ADDENDUM NO. 2 TO 18-0013-4

**FOR: JENNIFER ROSS SOCCER COMPLEX EXPANSION**

**JENNIFER ROSS SOCCER COMPLEX EXPANSION  
ITB #18-0013-4**

**ADDENDUM NO. 2**

**1 FIELD LIGHTING ONE-LINE DIAGRAM**  
E101 SCALE: NTS

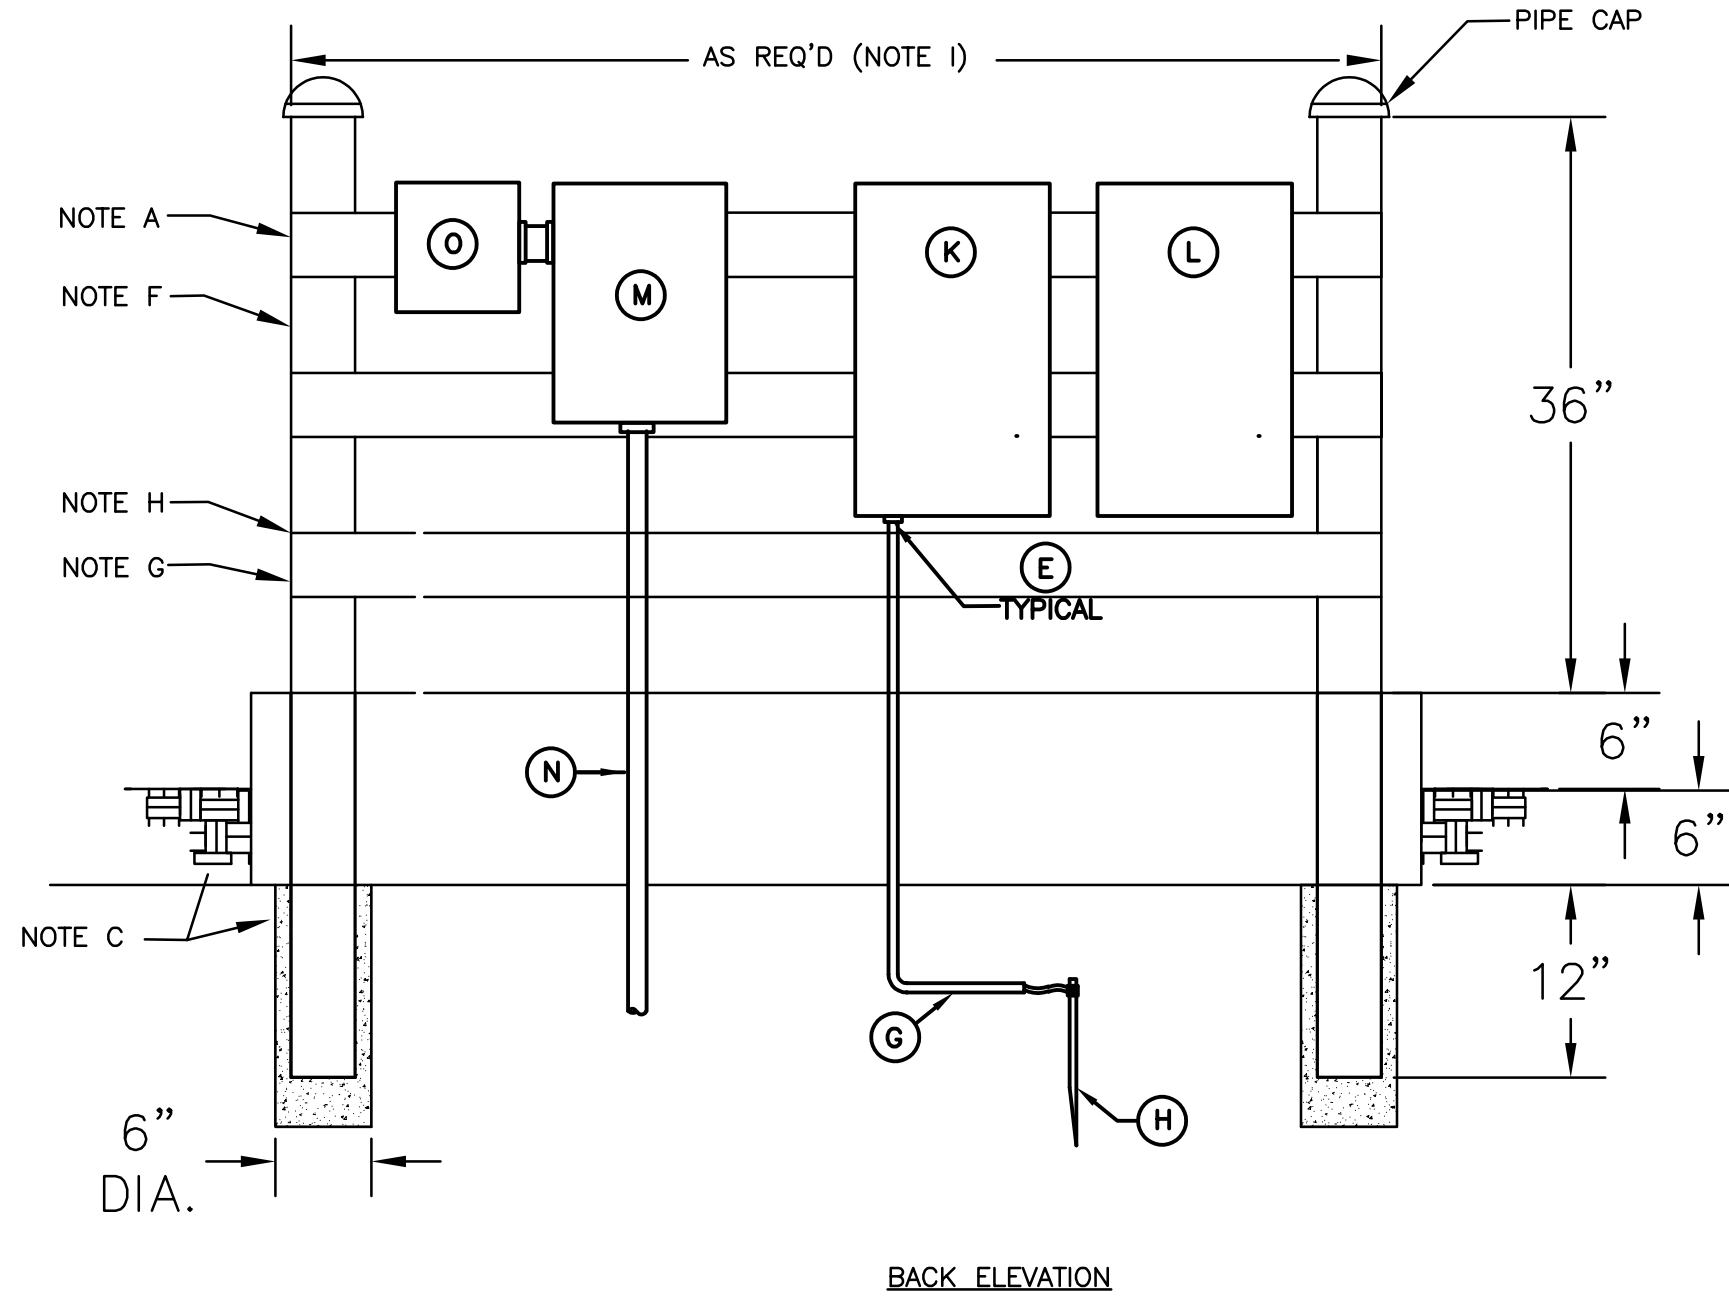
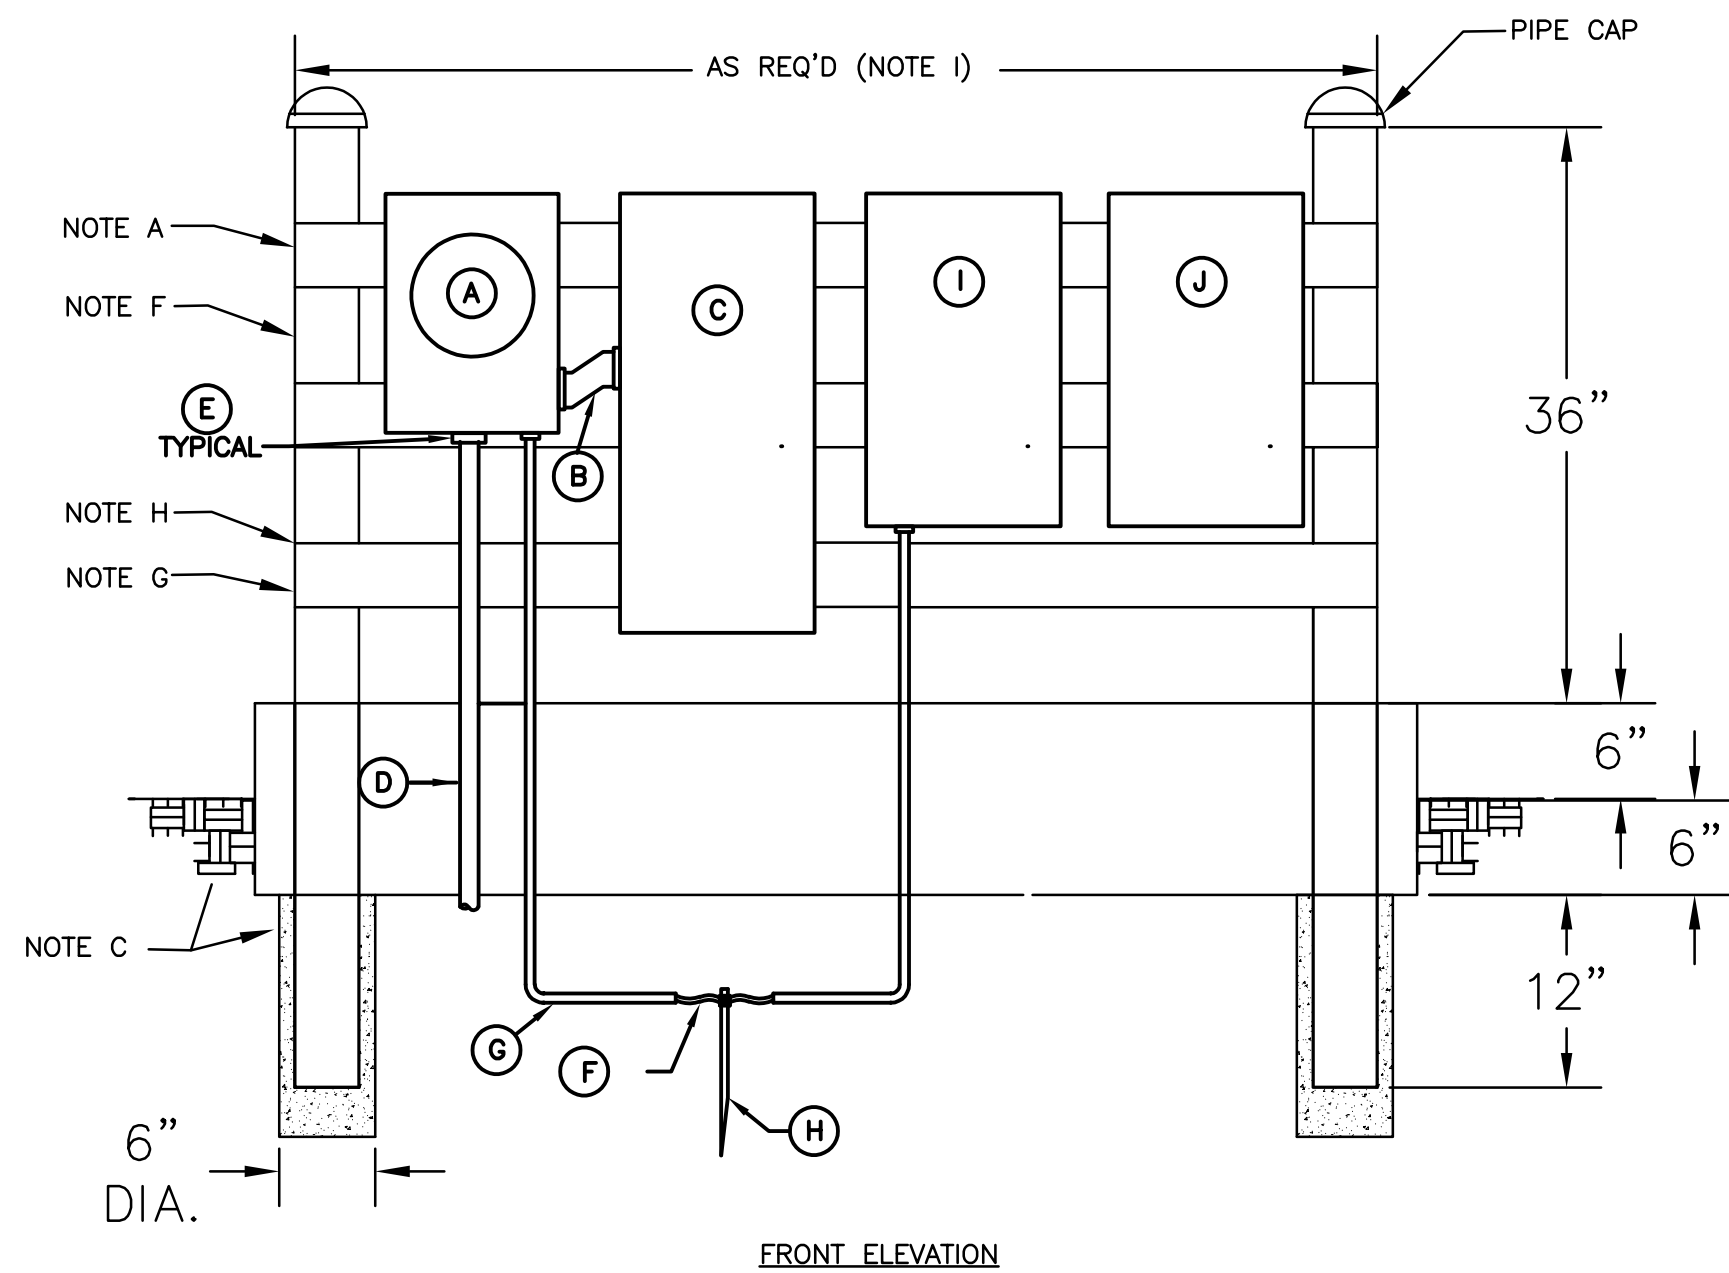
2. Please find attached revised drawing E-101\_RevA containing a revised field lighting one-line diagram.

11. Question: Please confirm size of emergency lighting inverter. Plans show 1000 KVA, but it is being fed from 40 A, 2 pole breaker. Is this a typo?

Answer: The emergency lighting inverter shall be 3000 VA. The inverter shall also be exterior rated or in a weatherproof enclosure.
